Access Compliance Report

Public Rights-of-Way

Intersection ID: 2549	Main Street: BEARDSLEY_DR	Cross Street: MCCHESENEY_DR	Location: E
ADA ID: 81185E6DBAF1	Ramp Type: BlendTrans1	Initial Pass/Fail: Pass	Overall Compliance: No
Severity Score: 7.5			
Codes/Mitigation Info/Possible Solution		Field Measurements/Component Compliance

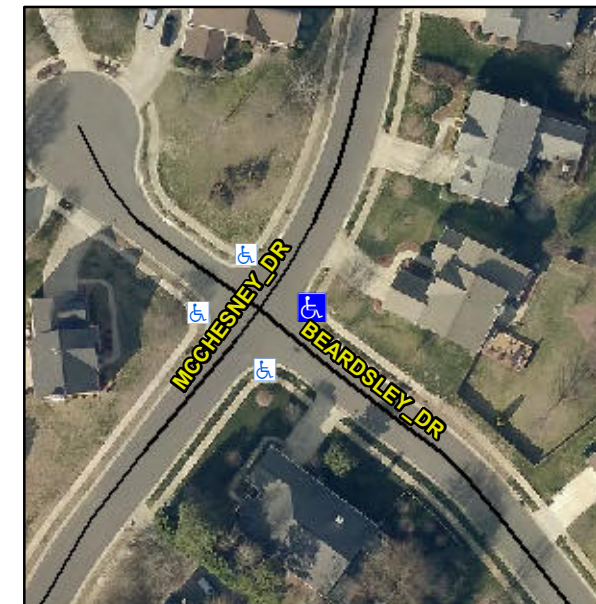
Remove & Replace Detectable Warning System. Remove & Replace Gutter.

R305.2, R302.7.2, R304.5.3
